Consultant	Wahib Medanat Consultant Engineer	Rep No.	12-16022022
Contractor	Derar Saraireh & Sons for Engineering & Contracting	Tender No.	(11/2019/USAID/SKEP/3/S) Schools for a Knowledge Economy Project (SKEP) - Phase (3) Package (1, 2)
Site Name	Al Khansa' Basic Mixed School- Al Balqa	Day/ Date	Wed. 16/02/2022
Duration of Project	450 Calendar Days	Total Project Budget	9,789,417.840 JD

### Visit Notes

(Figure: 05)

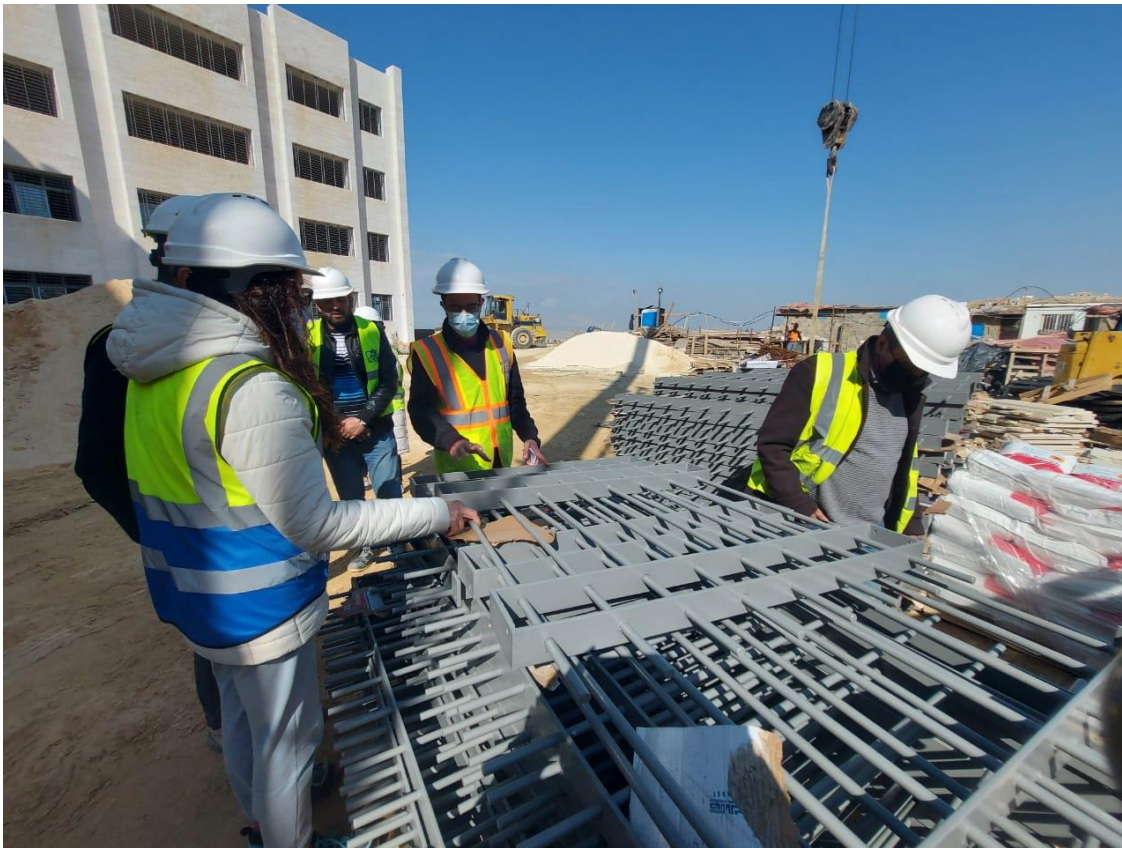
The team inspected the stone of the facades and observed that a number of defective stones were still not rectified
